ADDENDUM NO. 1

FEBRUARY 14, 2008

RFB NO. 108019 - NEW AIR CONDITIONERS & GENERATOR

DANE COUNTY PUBLIC WORKS

CITY-COUNTY BUILDING
REPLACEMENT GARAGE FLOOR PLAN
PLUS OPTIONS

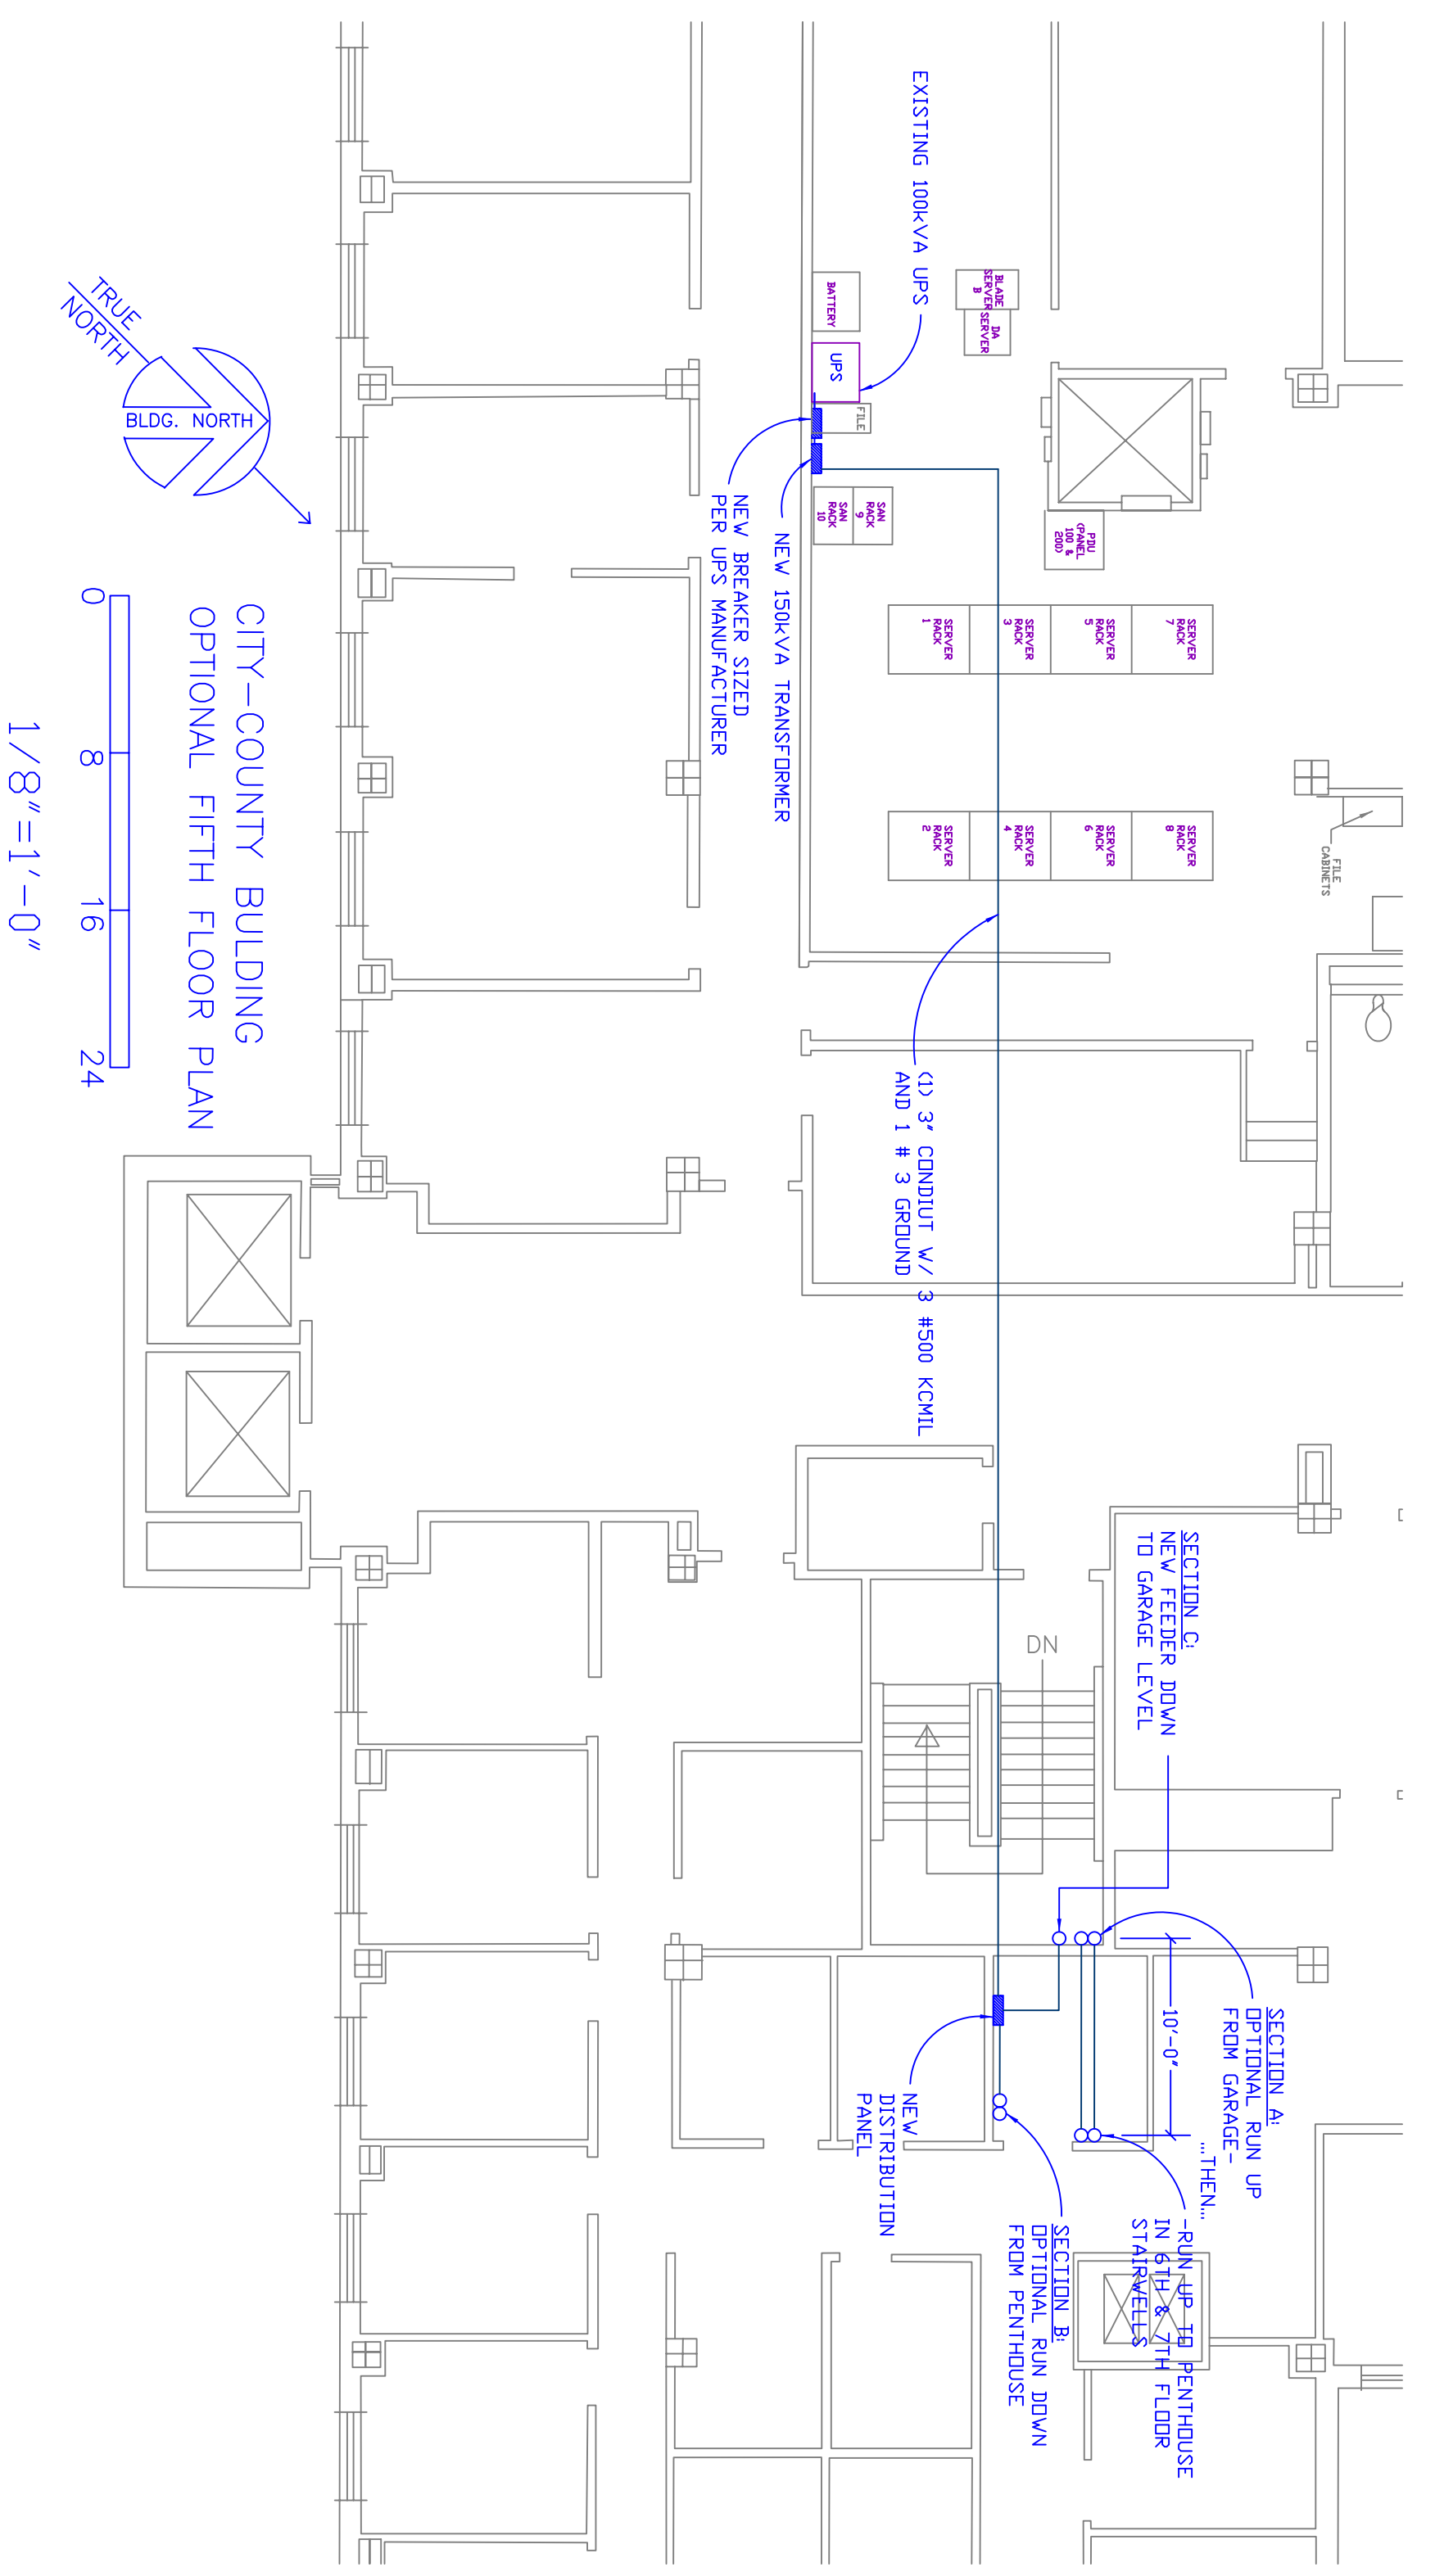
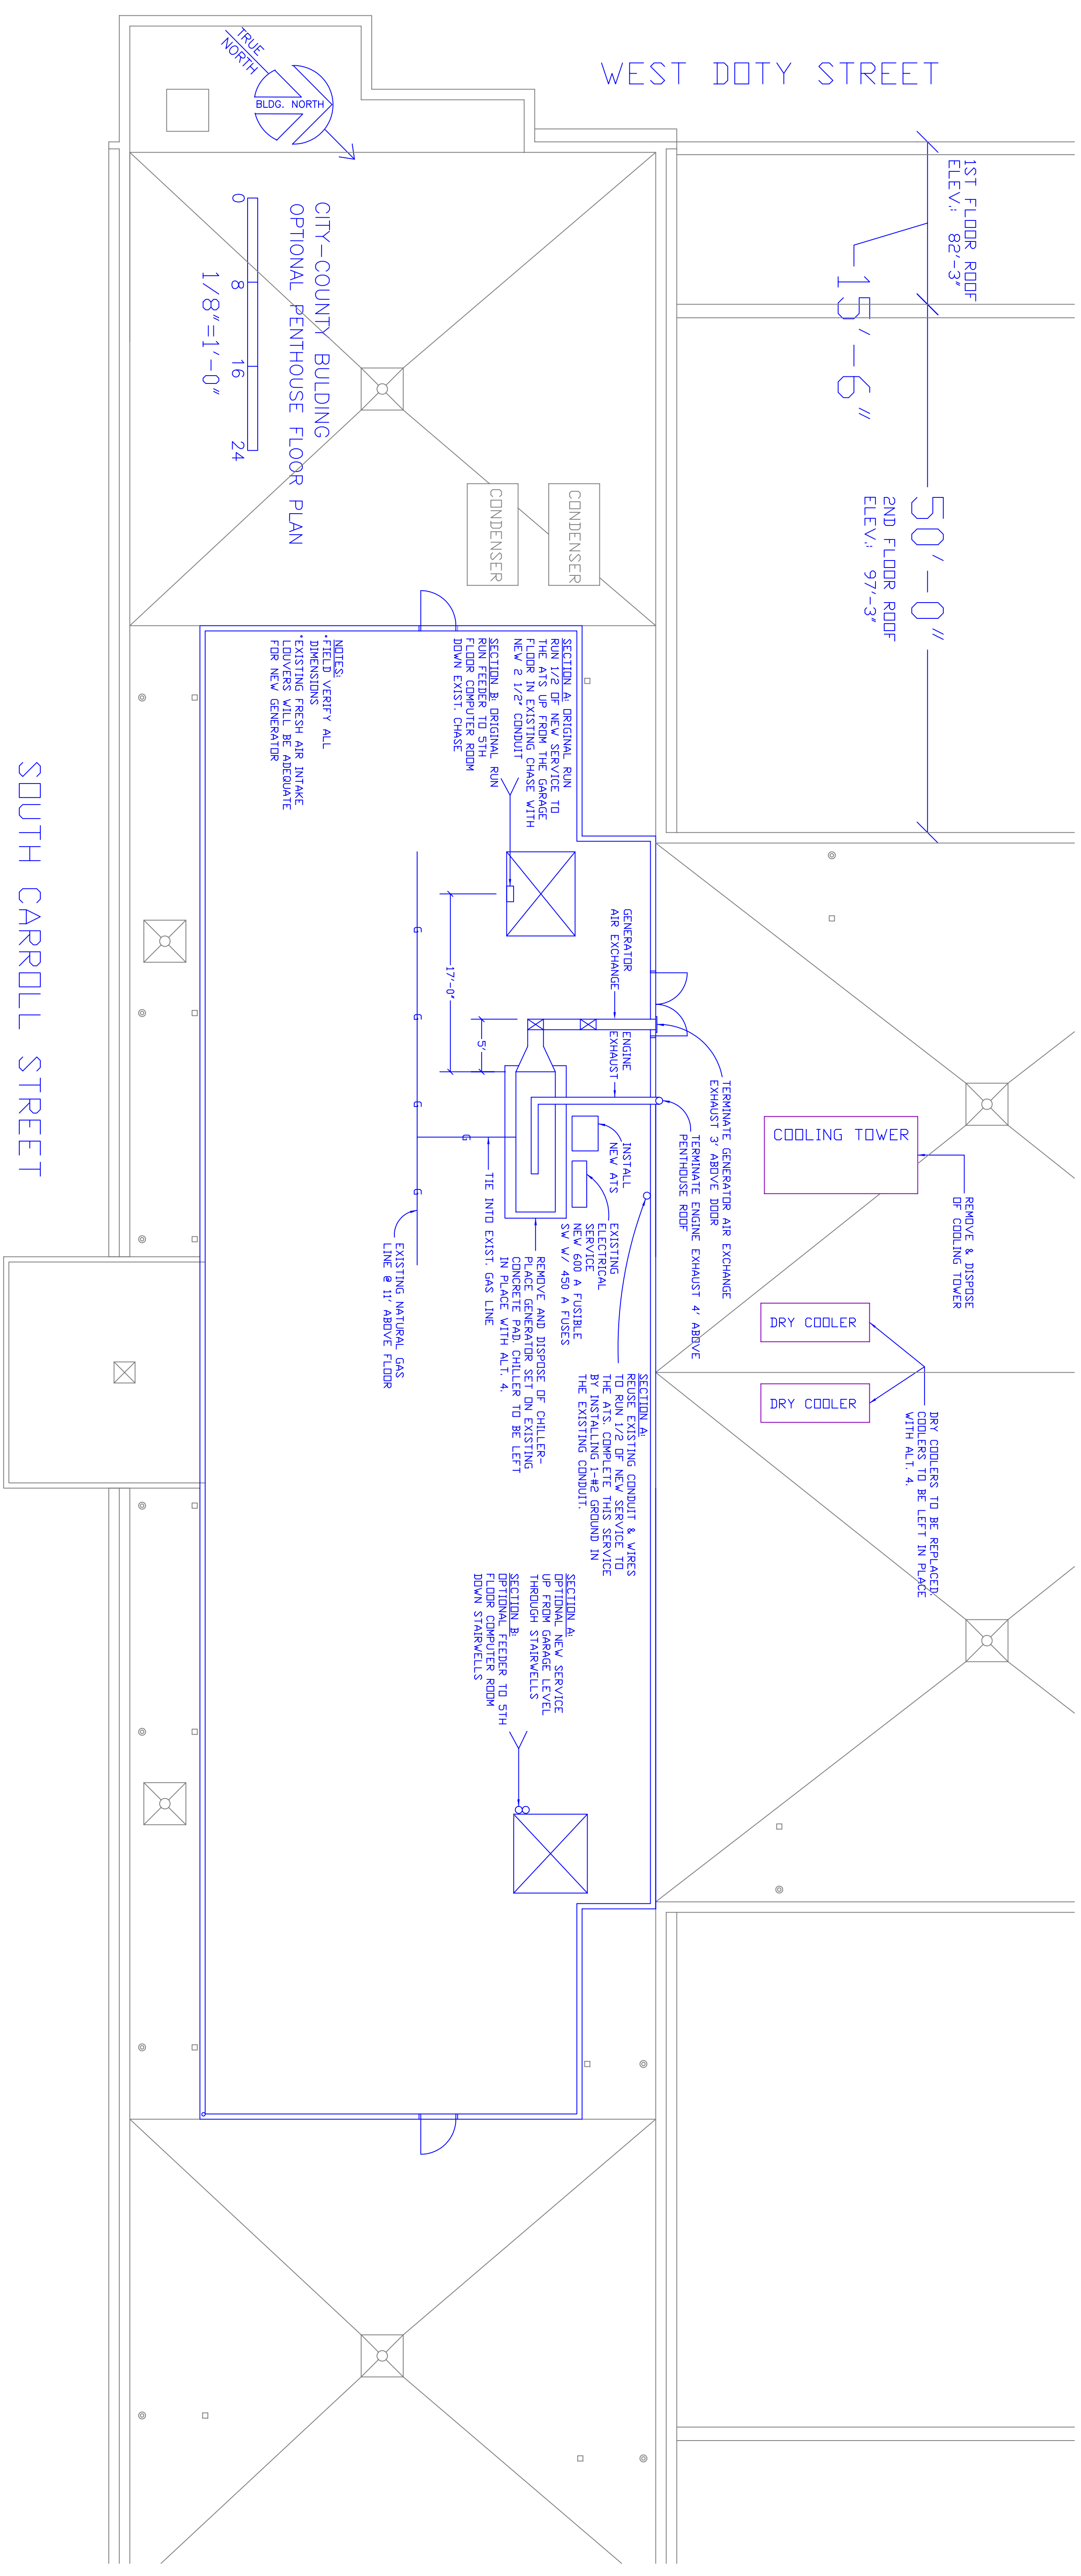
- a. Original Run: Provide four #4/0 wires with one #2 ground in a each new 2-1/2” conduit. Run conduits parallel from switchgear room down to the garage level. In the garage level, run conduits, as shown on Drawing 2 to location denoted as “Original Run.” Then, run conduit straight up to room GR-24. From GR-24, run the feeder up to room 321 through electrical closets. In room 321, it will run 20’ toward Doty St and 5’ toward MLK Jr Blvd in the drop ceiling. The drop ceiling in room 321 does not need to be replaced. Then run the feeder up, through the fourth floor storage room and through the existing 5th floor computer room chase, to the penthouse. As an option, Contractor may run this feeder adjacent to and outside the existing chase from 5th floor up to the penthouse, in order to avoid tight spaces and fire dampers in the chase.

- b. Optional Run: Contractor has the option to run this feeder up to the penthouse through existing stairwells. If this option is chosen, run conduits parallel from switchgear room down to the garage level. In the garage level, run conduits, as shown on Drawing 2 to location denoted as “Optional Run.” Then run feeders straight up, through the existing stairwell, to the fifth floor. Next, run feeders through the stairwell wall and 10’ towards Wilson St in a drop ceiling. Then, run feeders straight up to the penthouse through existing stairwells. Any conduit which is run in stairwells must be separated from the stairwell area by a 2 hour fire rated enclosure. Construct this enclosure of 1” shaft board and two (2) layers of 5/8” fire rated drywall over metal studs. Tape, finish, and paint to match existing walls.

1. From the new distribution panel, install a new 2” conduit with three (3) #250 KCMIL and one (1) #4 ground. Run this feeder down to the garage level along the same path as the new conduit of Section A. Once this conduit reaches the garage level, connect it to a new conduit denoted as Section D on Diagram 1 and Drawing 2.

1. Tie new 2” conduit with 3 #250 KCMIL and 1 #4 ground into new conduit from GR-24. Run this new feeder to a new 400 amp non-fused switch, a new 112.5 KVA transformer, and a new 400 amp distribution panel, as shown on Drawing 2 and Diagram 1. Finally, tie the City’s 40 KVA UPS and HVAC system into the new distribution panel with feeders sized per manufacturers’ recommendations.”

CITY-COUNTY BUILDING
OPTIONAL FIFTH FLOOR PLAN

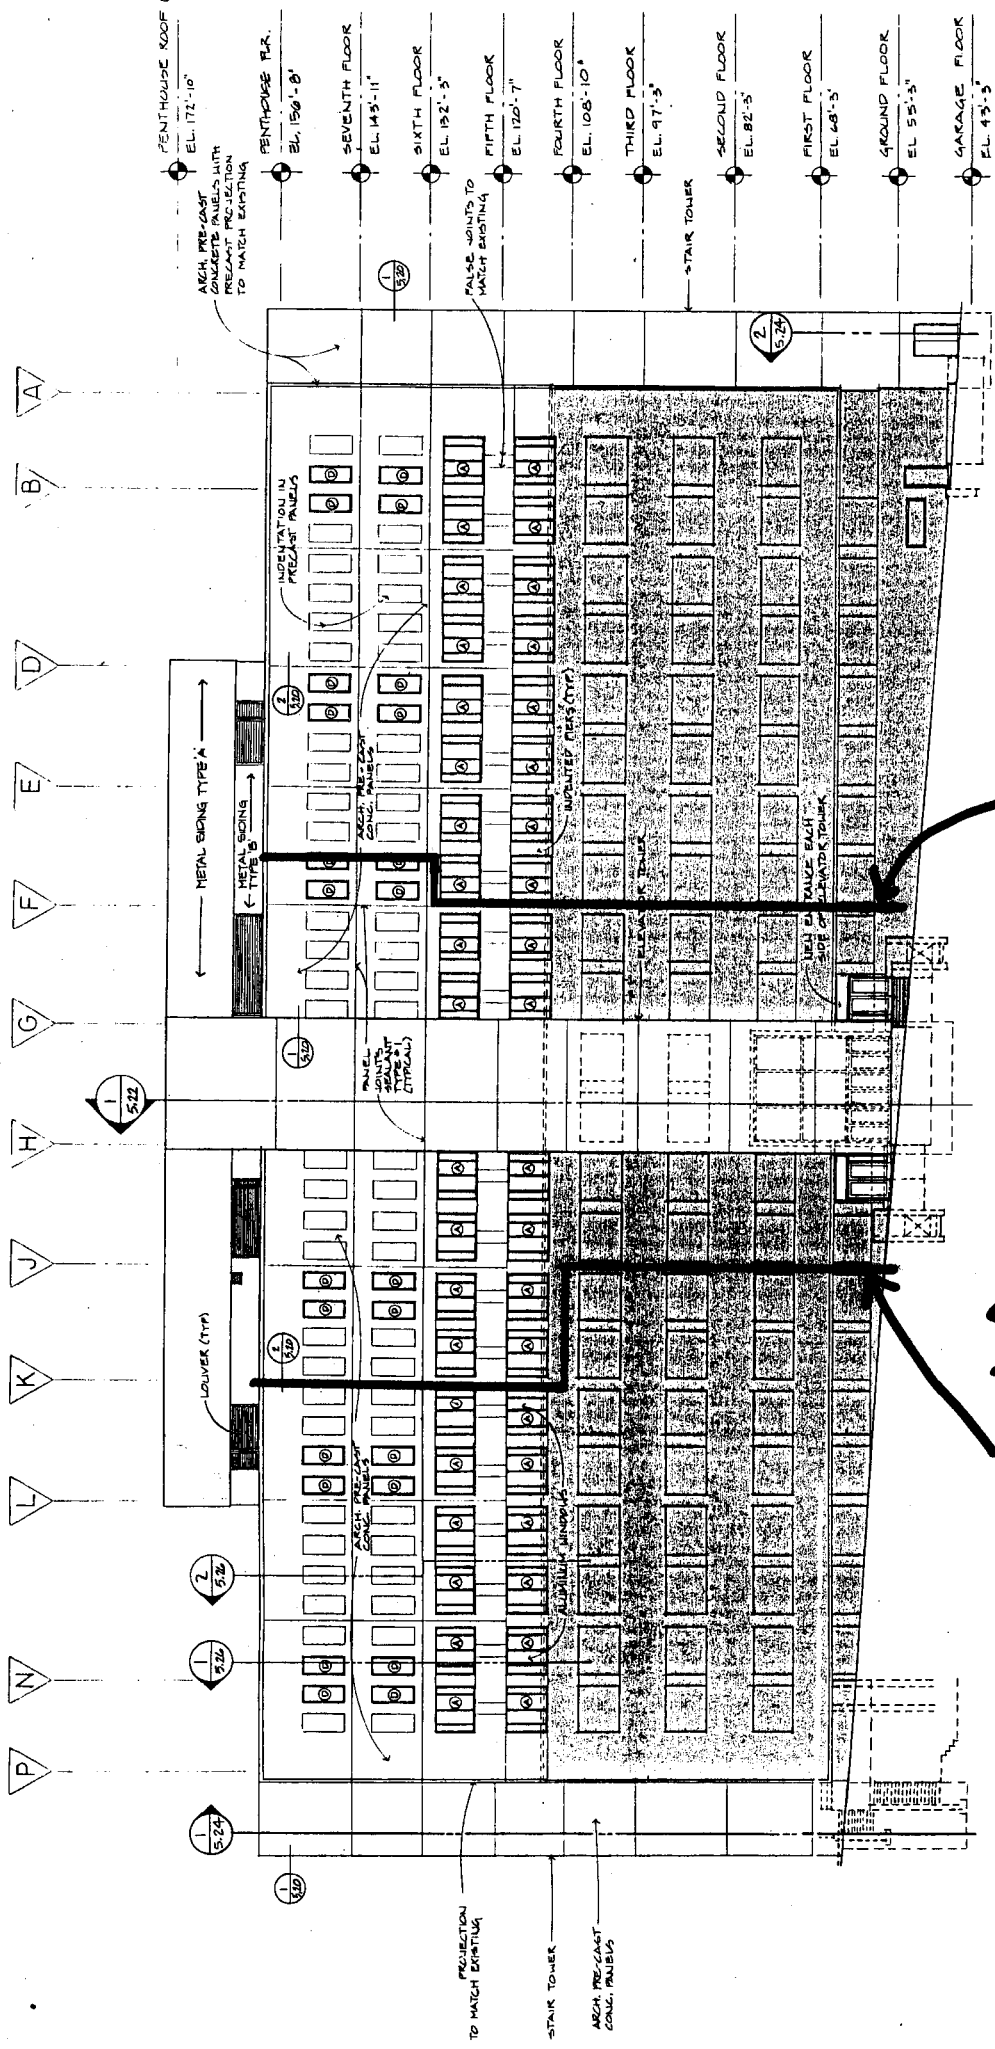
- b. Optional Run: Contractor has the option to run this feeder down to the fifth floor through the stairwells along the same path as was explained above. Once on the fifth floor, run the feeder to a new 600 amp distribution panel behind the stairwell, as shown on Drawing 3.

3. From the distribution panel, run service to the transformer, breaker, and 100 KVA UPS, as shown on Drawing 1, Drawing 3, and Diagram 1.
